SFO T1 ART PLAN: ARRIVALS

SFO SITE - ARTWORK POSITIONS - Av7 - REV 2.1 - JULY 26 2023 - EDIT

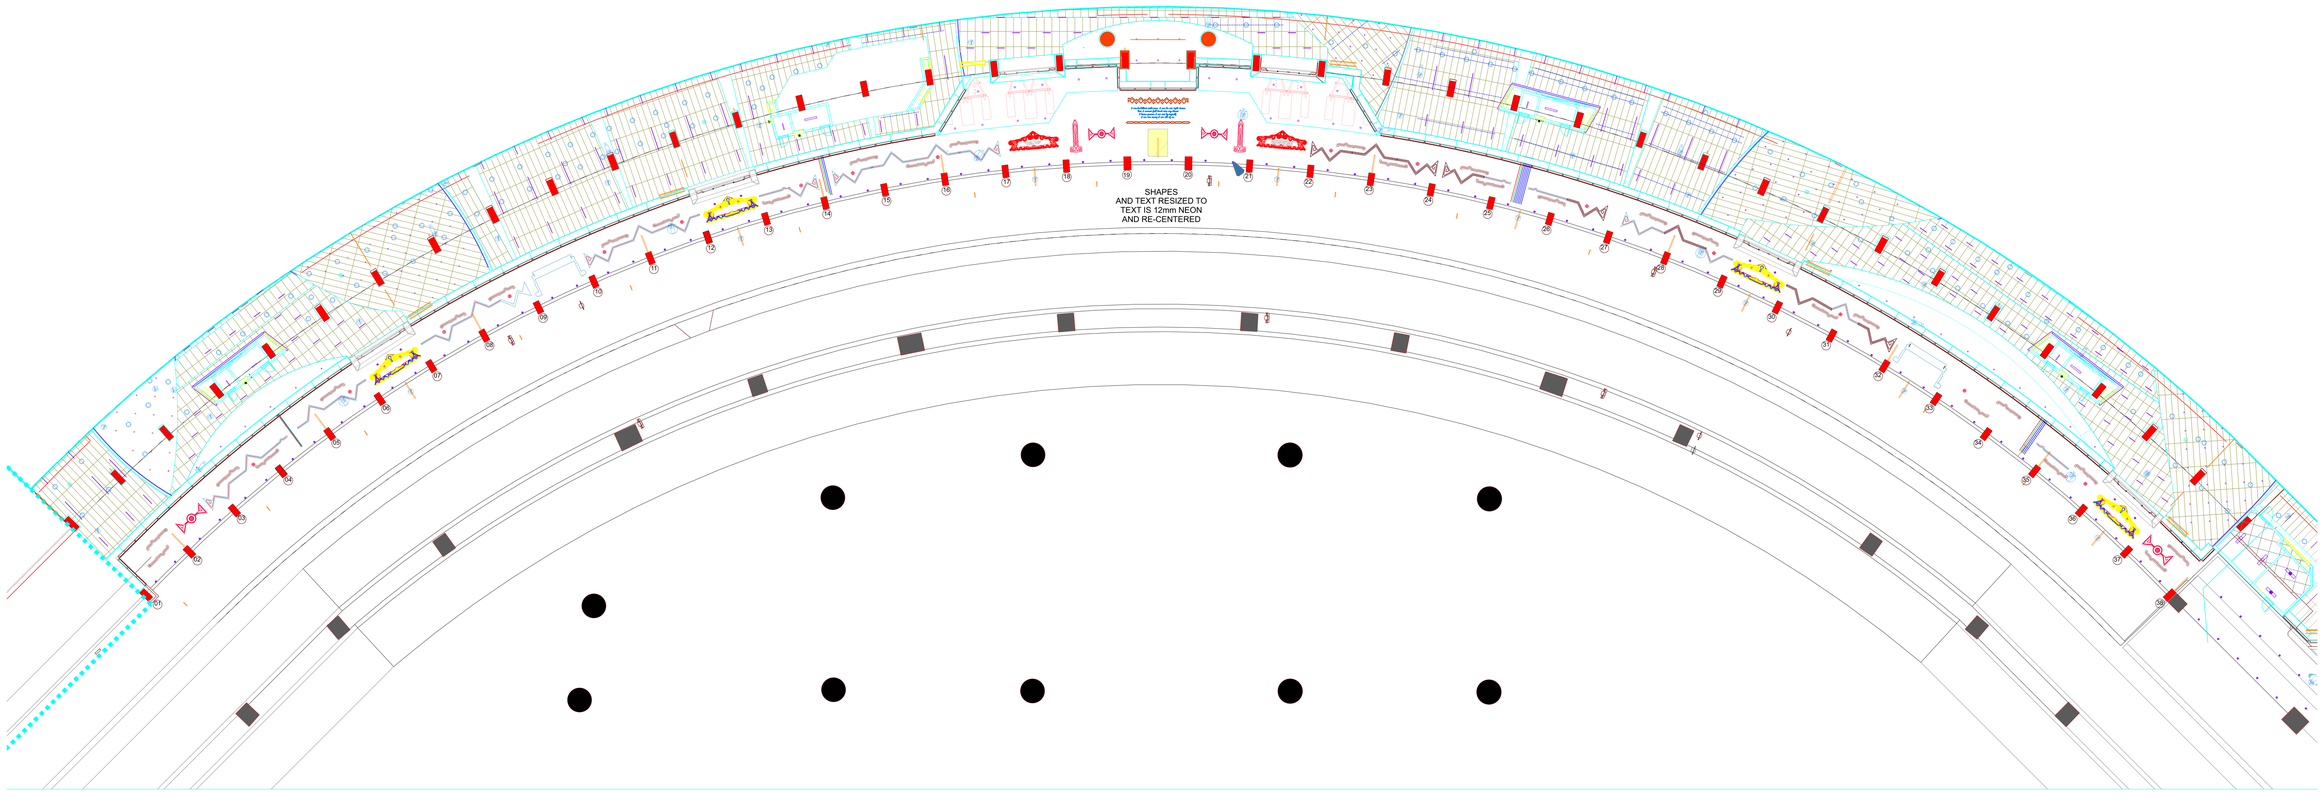
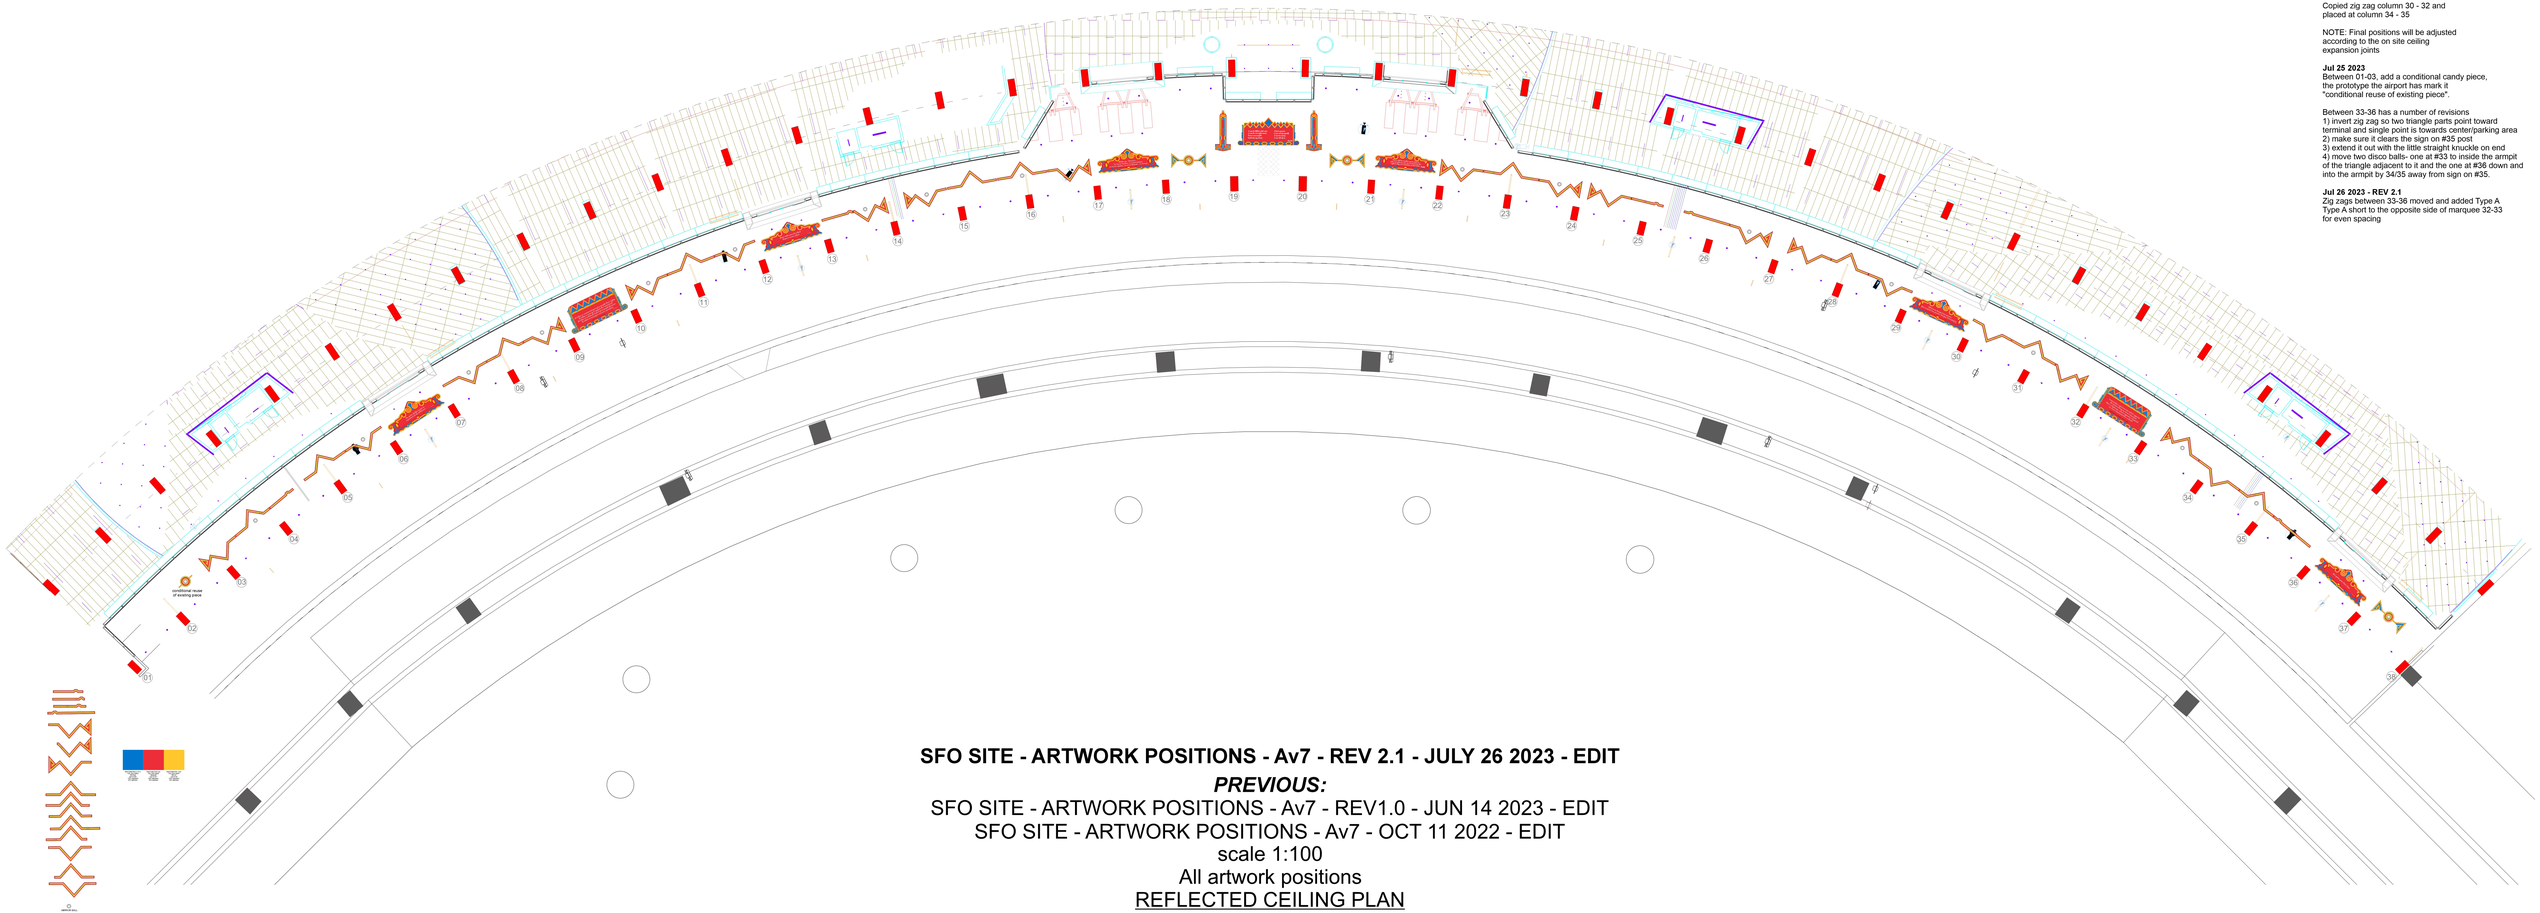
CHANGES:
Jun 14 2023:
Deleted all Bobby Pins and
zig zag at column 36.

Copied zig zag column 30 - 32 and
placed at column 34 - 35

Jul 25 2023
Between 01-03, add a conditional candy piece,
the prototype the airport has mark it
"conditional reuse of existing piece".

Between 33-36 has a number of revisions
1) invert zig zag so two triangle parts point toward
terminal and single point is towards center/parking area
2) make sure it clears the sign on #35 post
3) extend it out with the little straight knuckle on end
4) move two disco balls- one at #33 to inside the armpit
of the triangle adjacent to it and the one at #36 down and
into the armpit by 34/35 away from sign on #35.

Jul 26 2023 - REV 2.1
Zig zags between 33-36 moved and added Type A
Type A short to the opposite side of marquee 32-33
for even spacing

SHAPES
AND TEXT RESIZED TO
TEXT IS 12mm NEON
AND RE-CENTERED
